**Comment Response Document (CRD)  
to Notice of Proposed Amendment (NPA) 03-2005**

**for amending the Executive Director Decision No. 2003/09/RM  
on certification specifications, including airworthiness codes and acceptable  
means of compliance, for engines (« CS-E »)**

**Miscellaneous amendments to CS-E**

**Figure 1. Example of the analysis results for a system with both Short Time Dispatch and Long Time Dispatch**

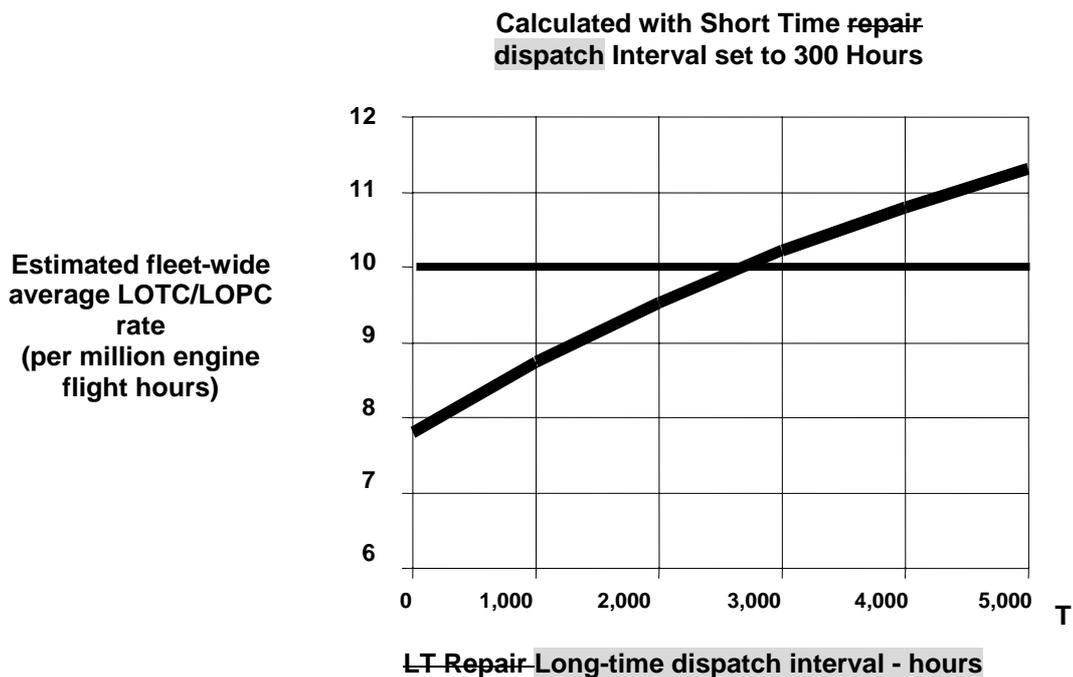
84.	Turbo- meca	B Proposal 11 AMC to CS- E 1030 Figure 1.	Modify Figure 1 and associated footnotes as follows:  **figure**	- Modification of heading of ordinates of figure 1: according to paragraph (4) of this AMC, this is the dispatch intervals not the repair intervals (only associated to repair maintenance approach).  - Modifications of notes are for clarification or completeness.	<b>Partially Accepted</b> Text has been modified, except for capital letters (see response to Comment 58).	(See Appendix).
